The Commission has issued the enclosed Amendment No. 30 to Facility Operating License No. DPR-75 for the Salem Nuclear Generating Station, Unit No. 2. This amendment consists of changes to the Technical Specifications in response to your request dated October 15, 1984.

The amendment revises the final acceptance criteria envelope for "K(z) Normalized  $F_0(z)$  as a Function of Core Height," Figure 3.2-2 in the Technical Specifications.

AMENDMENT TO FACILITY OPERATING LICENSE

SAFETY EVALUATION BY THE OFFICE OF NUCLEAR REACTOR REGULATION  
RELATED TO AMENDMENT NO. 30 TO FACILITY OPERATING LICENSE NO. DPR-75

FIGURE 3.2-2  
 $K(z)$  - NORMALIZED  $F_Q(z)$  AS A FUNCTION  
 OF CORE HEIGHT

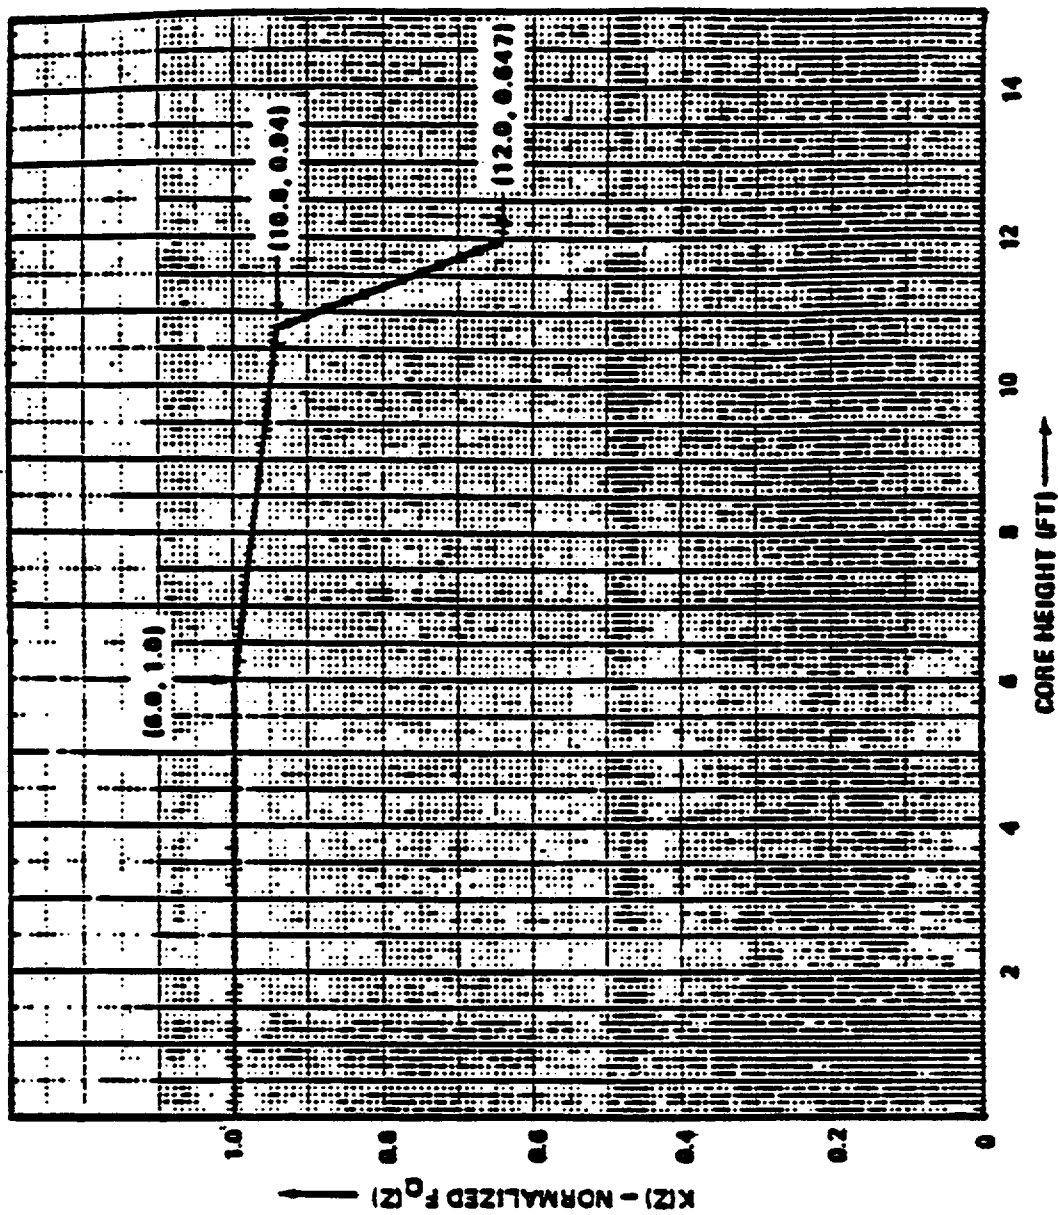
By letter dated October 15, 1984 Public Service Electric and Gas Company requested a revision to Technical Specifications Section 3.2.2 for the Salem Generating Station Unit No. 2. The revision consists of a change to Figure 3.2.2, " $K(z)$  Normalized  $F_Q(z)$  as a Function of Core Height".

The revision to the current  $K(z)$  curve is necessary to eliminate the potential violation of the third line segment of the  $K(z)$  curve during Cycle 3 operation of Unit 2. Cycle 3 will be the first 18 months cycle for Unit 2. From preliminary analysis, Unit No. 2 Cycle 3  $F_Q(z)$  values will be similar to those of Unit No. 1 Cycle 6 which is also an 18 month cycle. The proposed Technical Specification change is already in effect for Unit No. 1.

The change to the  $K(z)$  curve is allowable because a new small break LOCA analysis was done for Units 1 and 2 in 1979. NRC reviewed and approved this  $K(z)$  curve change for Unit 1 as part of the Cycle 2 Reload. The change was never made to the Unit 2 Technical Specifications since it was not needed. We have reviewed the results of the small break analysis and agree with the previous approval. We have also verified the Westinghouse results for the third line segment of the  $K(z)$  curve which is the requested Technical Specification change and agree that it is correct.

Based on our review we agree with the licensee that the change does not constitute a significant hazards consideration and approve this requested change to Technical Specification Figure 3.2.2.
